PLANNING COMMISSION MEETING AGENDA REGULAR MEETING

5. PLANNED UNIT DEVELOPMENT (File Number PUD 020 JPLN2023-0021) – CONCEPT DEVELOPMENT PLAN (CDP) AND PRELIMINARY DEVELOPMENT PLAN (PD) APPROVAL – The Village of Hastings PUD, East side of Livernois, north of Square Lake, PIN 88-20-03-301-088, -023, -024, -025 and 88-20-03-351-004, Section 3, Presently zoned NN (Neighborhood Node “Q”) and R-1B (One Family Residential) Zoning Districts.

PUD and Preliminary Development Plan Approval Review For City of Troy, Michigan

Action Requested: PUD and Preliminary Development Plan Approval Review

Scale: 3/8" = 1'-0"

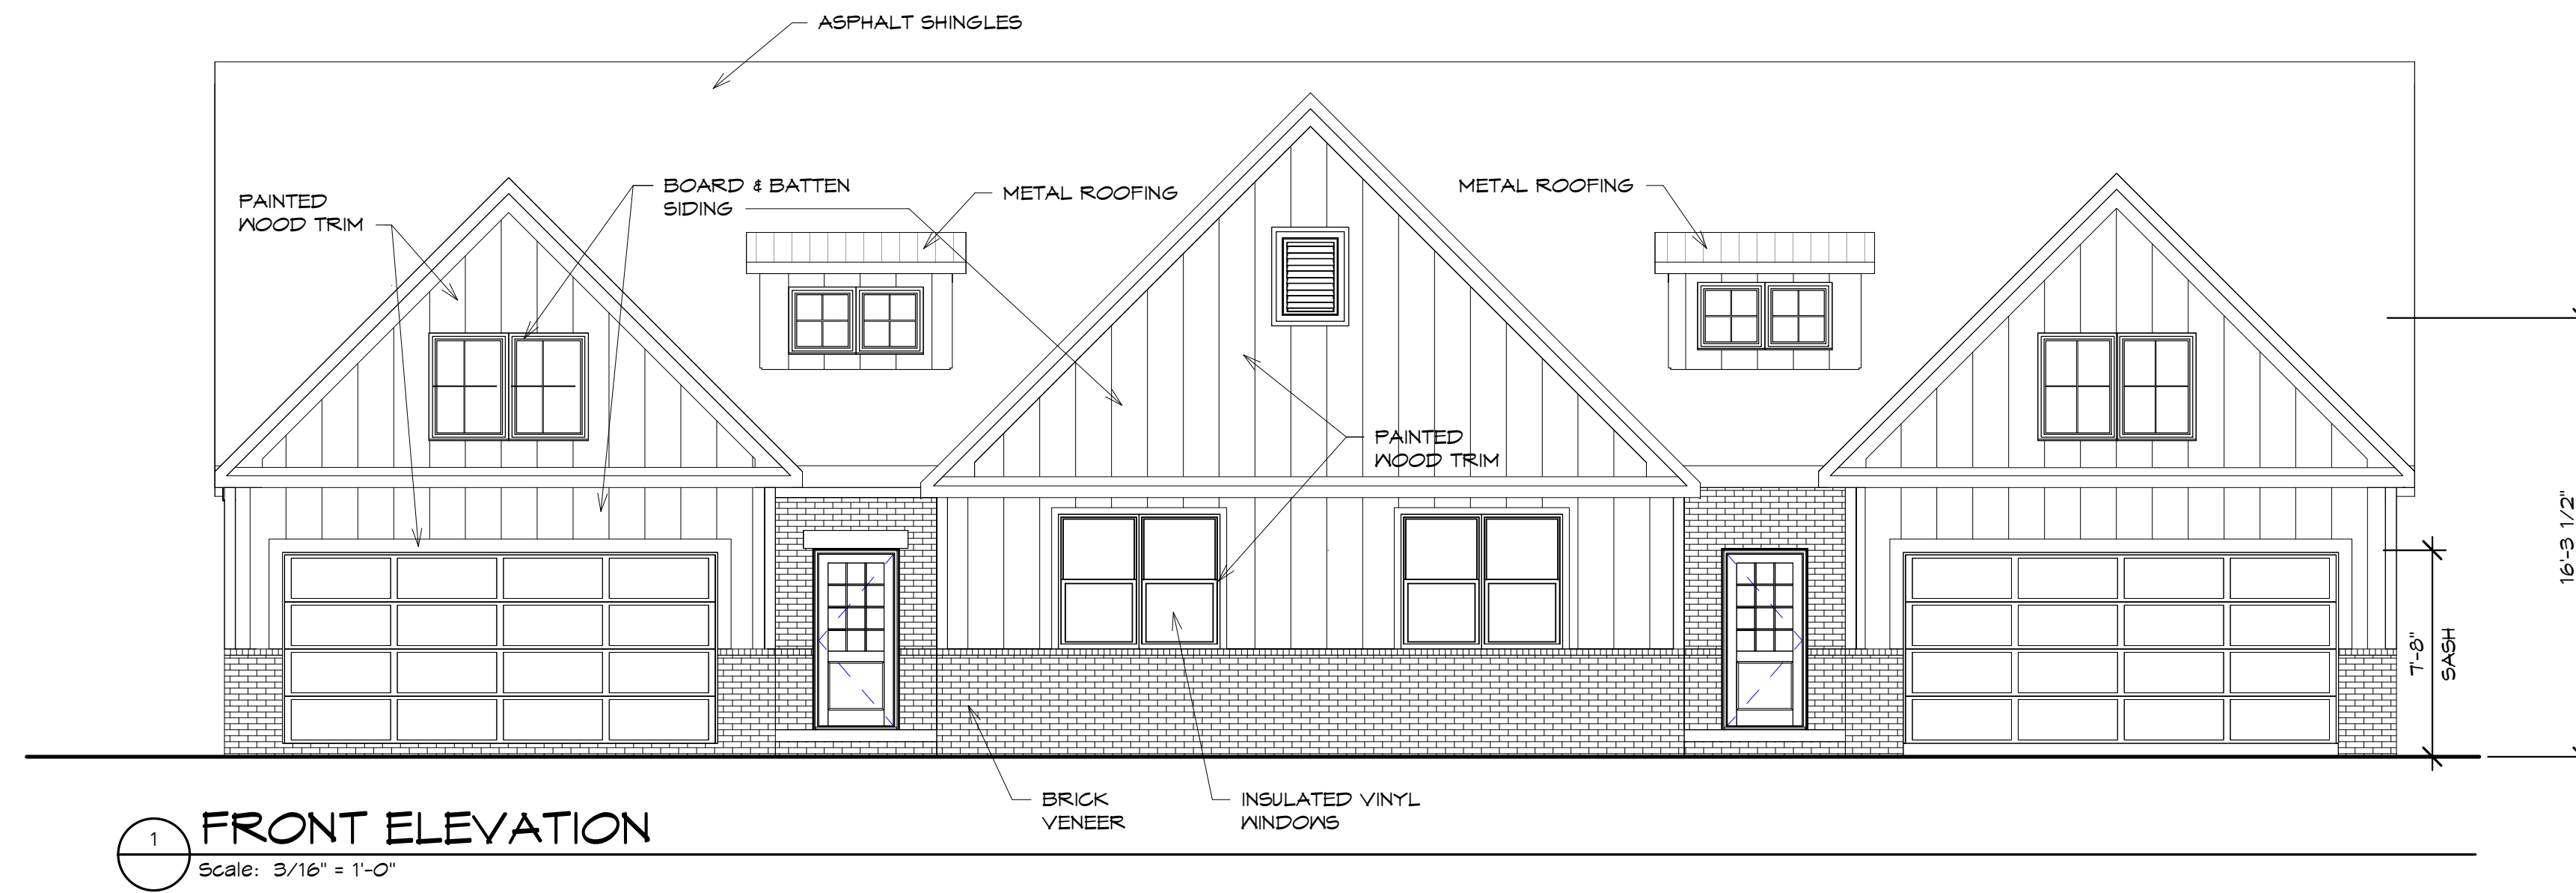
We note that since the April 9th Planning Commission meeting, the applicant has revised aspects of the building design to address architectural concerns. The “snout nose” appearance of the ranch units has been reduced, and more windows and architectural details have been incorporated to enhance natural light and building appearance. See the latest colored renderings below.

Items to be Addressed: *Planning Commission to evaluate proposed architecture in accordance with Site Plan Review Design Standards of Section 8.06.*
